**AGENDA**  
**CITY OF CREVE COEUR**  
**PLANNING AND ZONING**  
**300 NORTH NEW BALLAS RD**  
**SEPTEMBER 16, 2024**  
**6:00 PM**

- 1. Public Hearing. #24-023: An Amendment to an Existing Conditional Use Permit with Associated Site Development Plan for St. Louis Elks Lodge #9 Located at 12481 Ladue Road**

### #24-023: A NEW CONDITIONAL USE PERMIT WITH ASSOCIATED SITE DEVELOPMENT PLAN FOR THE ST. LOUIS ELKS LODGE #9 LOCATED AT 12481 LADUE ROAD

**RE: Elks Lodge #9 – Expansion Project**  
**Conditional Use Permit Amendment with Site Development Plan**  
**Application #24-024**  
**Response Letter**  
**Stock Project No. (2023-7477)**

**Figure 5: Existing Dumpster Location (left) and Proposed Dumpster Enclosure Shown on Plans (right).**

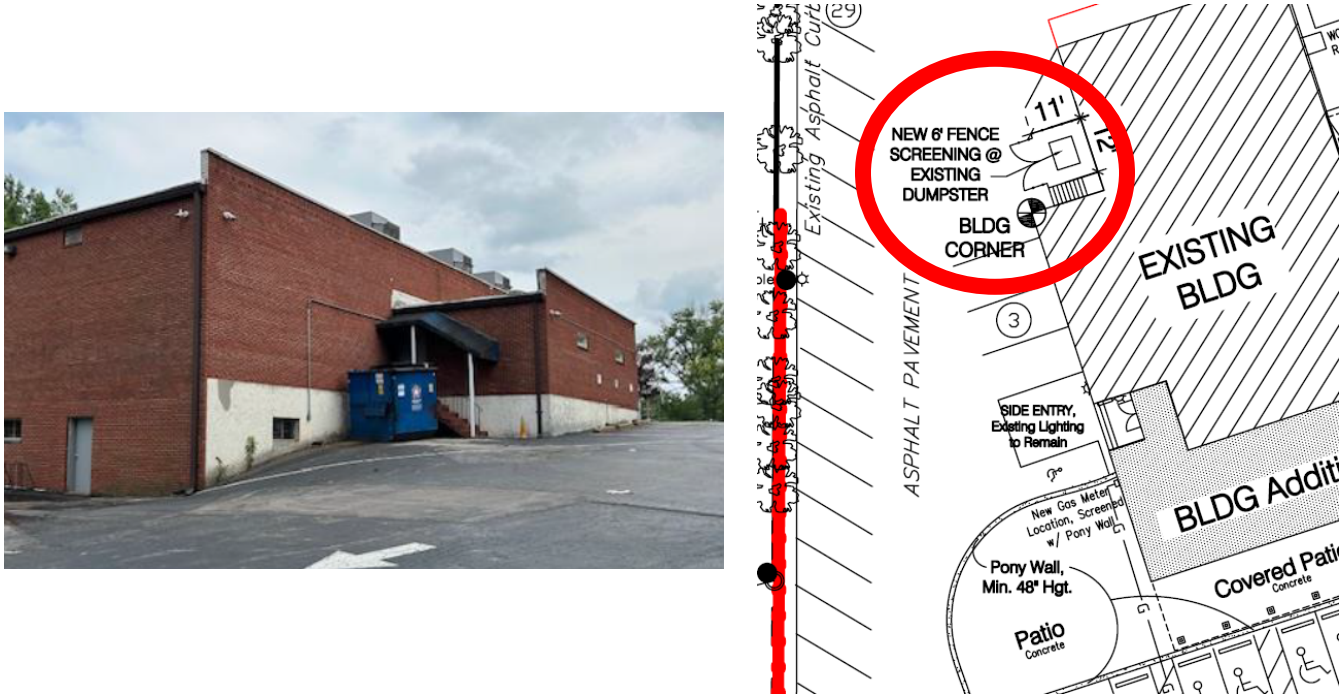
The design of off-street parking areas should limit vast open areas of asphalt parking spaces, especially in the front of commercial buildings. Parking lots need to be broken up into smaller, palatable spaces interconnected by landscaped pedestrian linkages. These linkages should be separate pedestrian walkways buffered with landscaping. Parking areas located to the side or rear of commercial buildings or parking structures to replace large open asphalt parking areas are encouraged (p.19.) Building services, such as delivery and trash enclosures, should be located in the less visible areas and screened (p.10.) The majority of the parking lot is existing and the proposed 20 additional spaces are shown broken up into two groups of ten with landscaping in between. The parking stalls are proposed to be in front of the building but will sit back several hundred feet from Ladue Road. Staff recommends that additional low landscaping be placed in front of the new parking stalls to reduce headlight glare and buffer the parking from Ladue Road to comply with the requirements for parking lots adjacent to right-of-way per Section 405.810.A.5.b. Although the parking is located roughly 400 feet from Ladue Road the space is relatively open. A condition of approval has been added to reflect this recommendation. The existing dumpster, though blocked from view by the building, is without an enclosure and the applicant has provided a new trash enclosure on the plans of a neutral-colored vinyl sight proof fence to screen it.

**Figure 6: Fence Detail per Plans.**

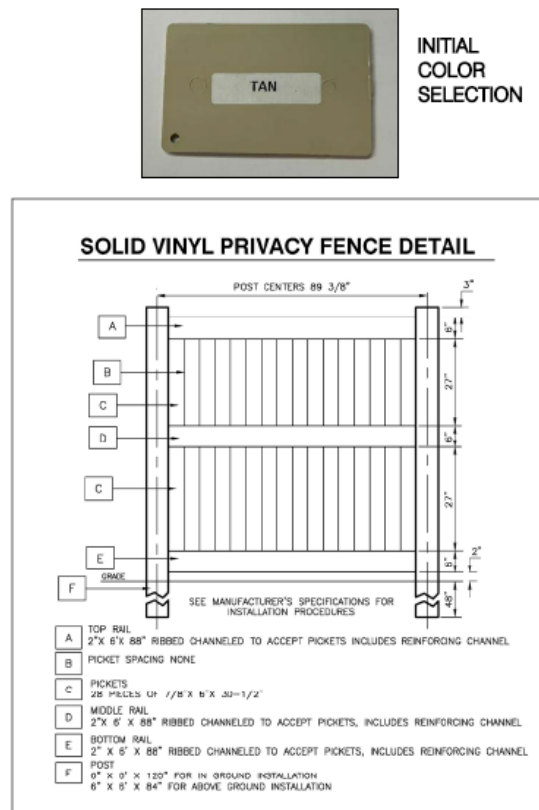
As discussed above, the Applicants have included a 290 foot long 6-foot-tall sight-proof vinyl fence to buffer the residences and provide headlight screening. The fence does not extend the entire length of the property line, and the applicants have stated this is due to the fact that the adjacent residents would like to preserve as much of the existing foliage along the property line as possible while also providing a barrier between the parking lot and the houses. The Commission should review the proposed location of the fencing and determine if it is sufficient or if more should be added. Staff have included in the condition that the fence shall be a neutral color.

Figure 7: Landscaping Detail with Fence Location in Red.

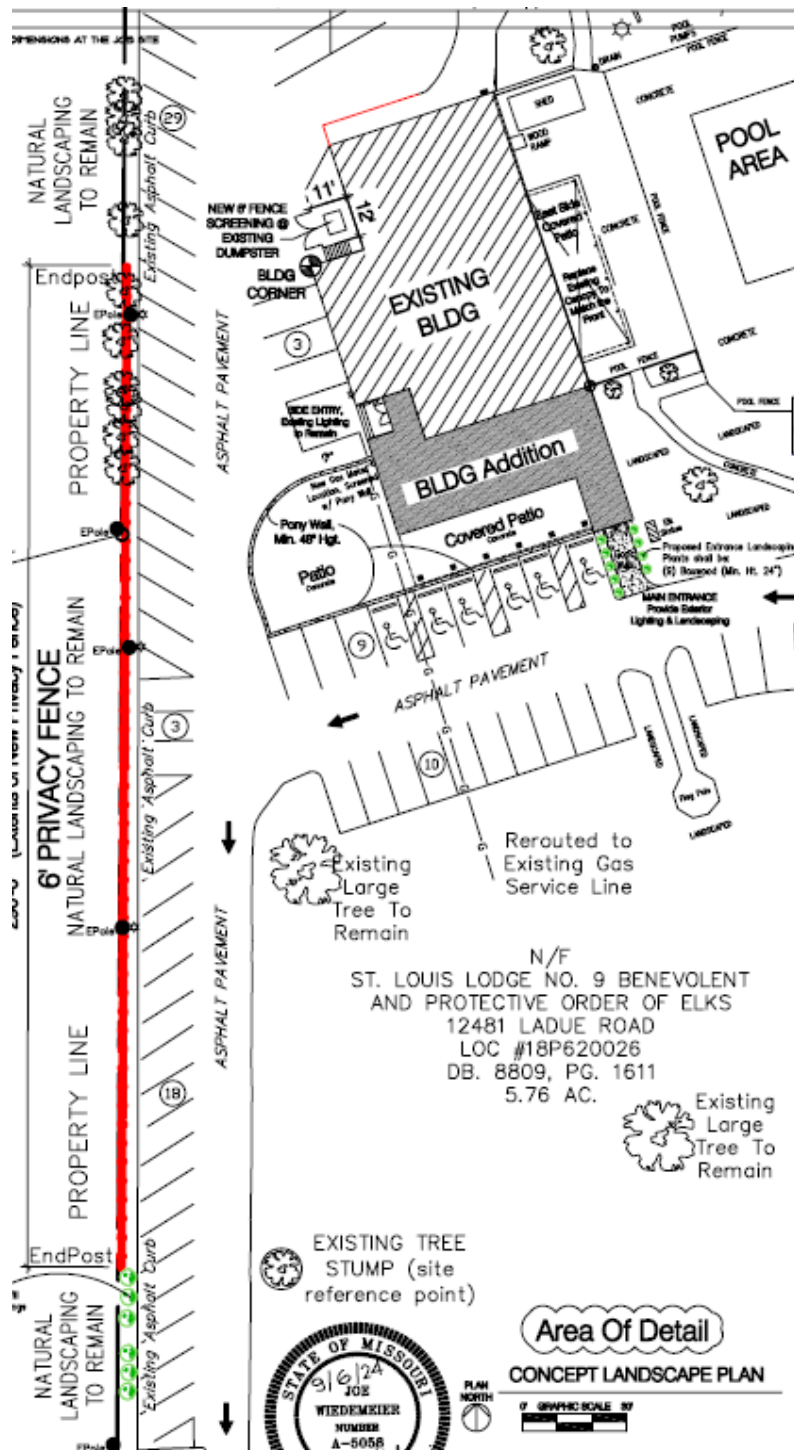
A landscaping plan was provided but staff have added a condition of approval that a final landscaping plan be submitted for staff review to address the items mentioned below. The Applicants are relying on the combination of the existing vegetation, the new fencing and minimal new landscaping to meet with the Code requirement in as much as the existing conditions will allow since a buffer cannot be provided on the west side of the property. The landscaping plan states that 6 boxwood shrubs will be added to screen the 5 parking spaces closest to Ladue Road that are not covered by the fence. Additional boxwoods are proposed along the entry sidewalk in front of the building. The landscaping plan shows that

landscaping will be provided between the two sets of ten new parking spaces, but no further plant information is provided. Staff have added a condition of approval that additional low landscaping be added in front of the new parking spaces to comply with Section 405.810.A.5.b and screen any headlight glare from Ladue Road. Staff recommends that the Commission review the proposed screening along the property line and discuss with the Applicant to determine if the proposed improvements are sufficient or if the fence should be extended further along the full length of the parking area or additional landscaping added.

SHEET TITLE:  
EXISTING  
CONDITIONS &  
DEMOLITION PLAN

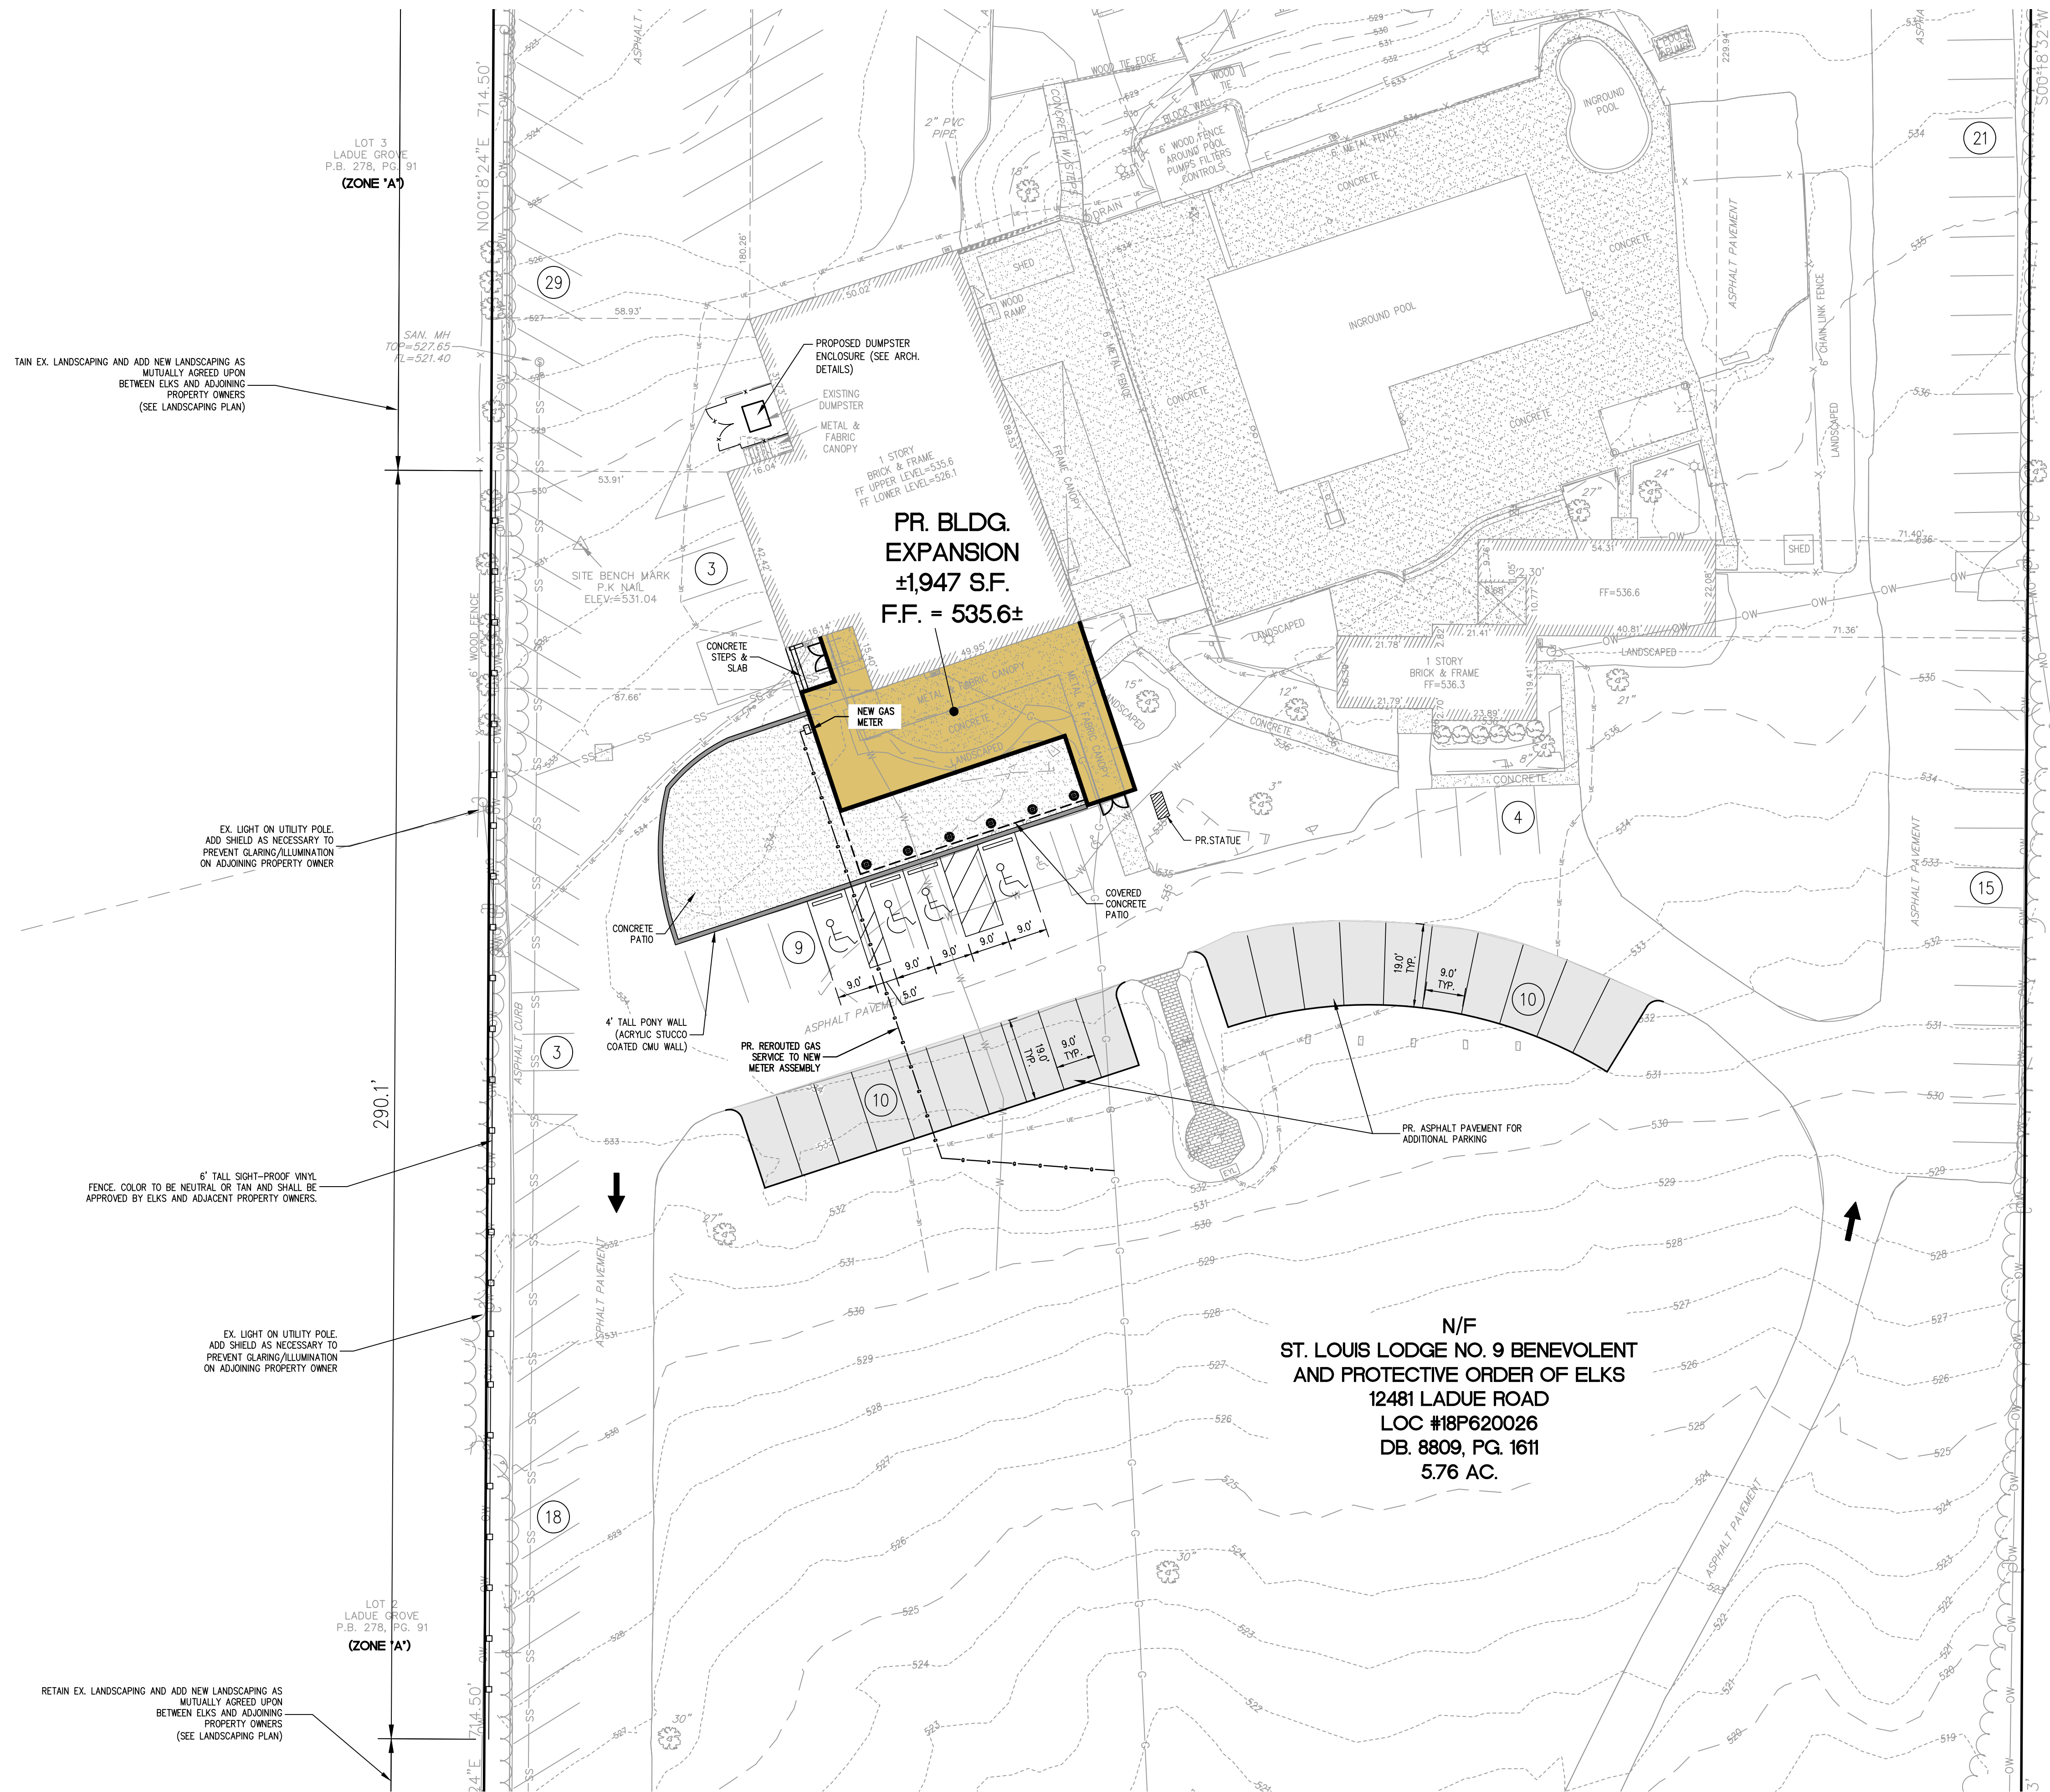
2. *Please provide an existing conditions and demolition sheet to the plans.*  
**Response: See new plan sheet C2 showing the existing conditions and demolition plan.**

SHEET TITLE: SITE  
PHOTOMETRIC  
PLAN

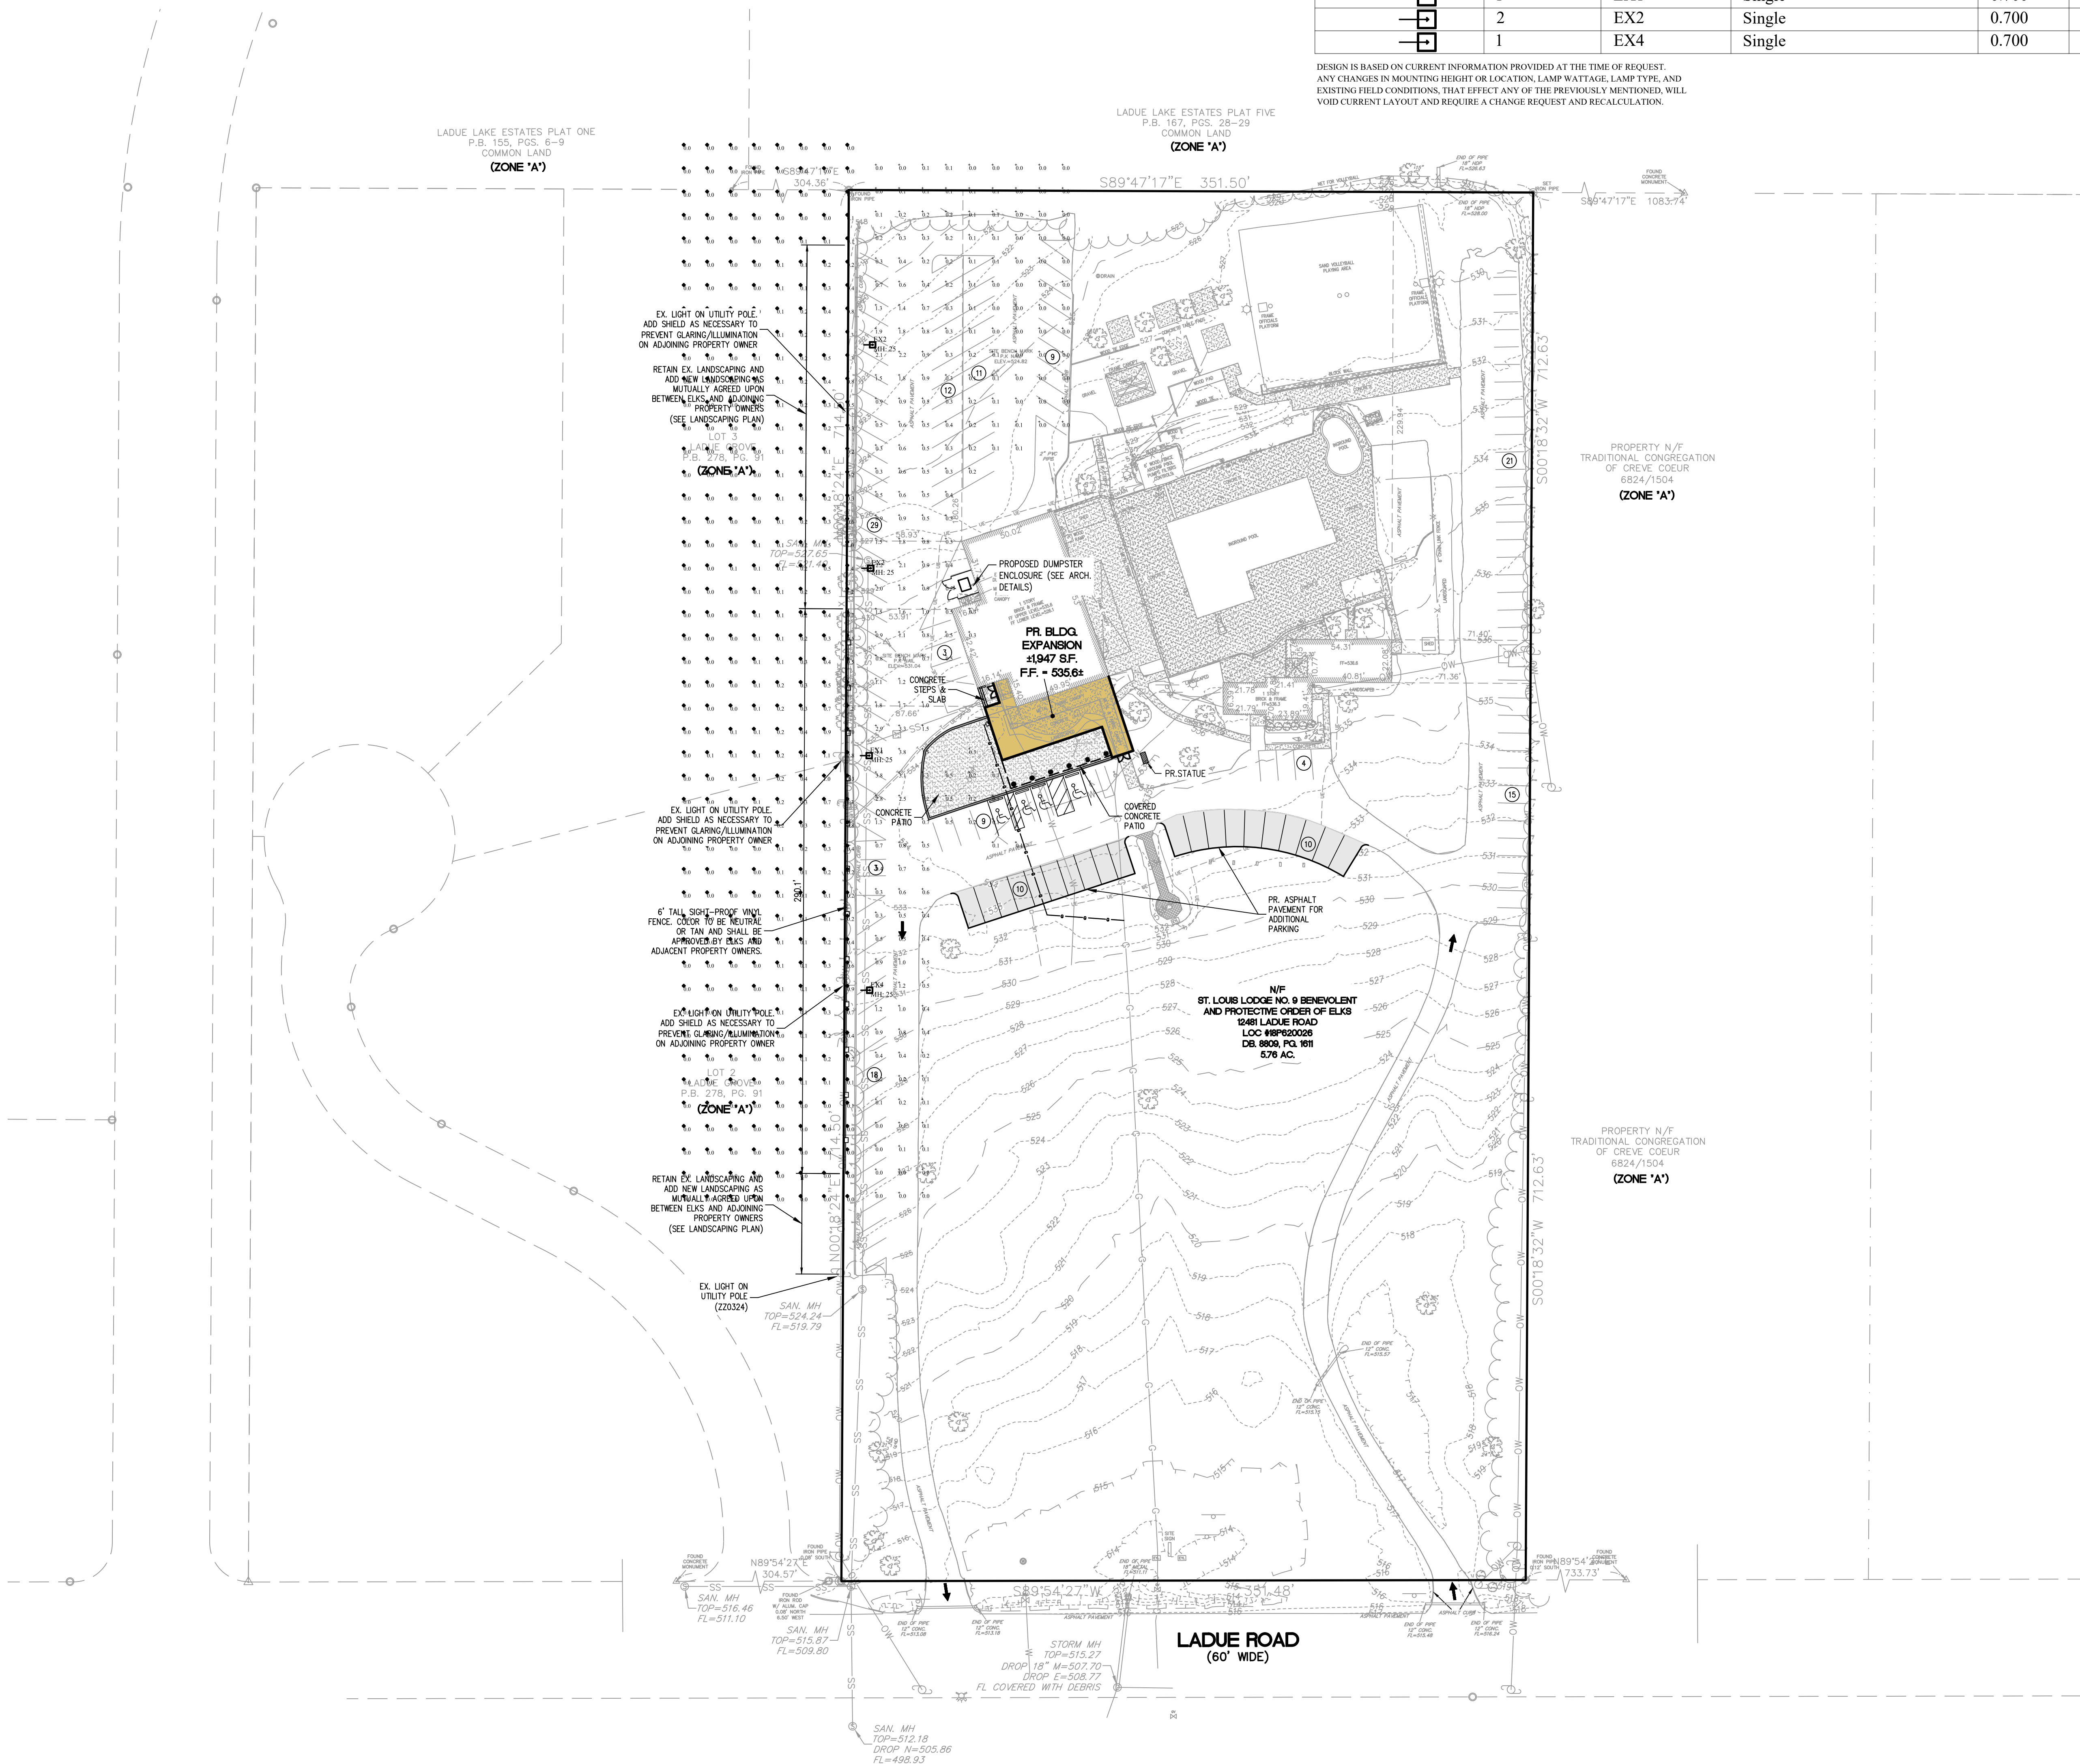
Staff asked that any existing lighting on the west side of the building and any new lighting be downcast and shielded so as not to emit light above a 90-degree angle as required by Section 405.680. The photometric plan provided shows that light levels along the west property line are compliant with this section. A condition of approval has been added to reflect this.

**Response:** All light fixtures along the west property line shall be shielded as necessary. A photometric plan has been prepared to show lighting levels along the west portion of the site and on the residential properties.
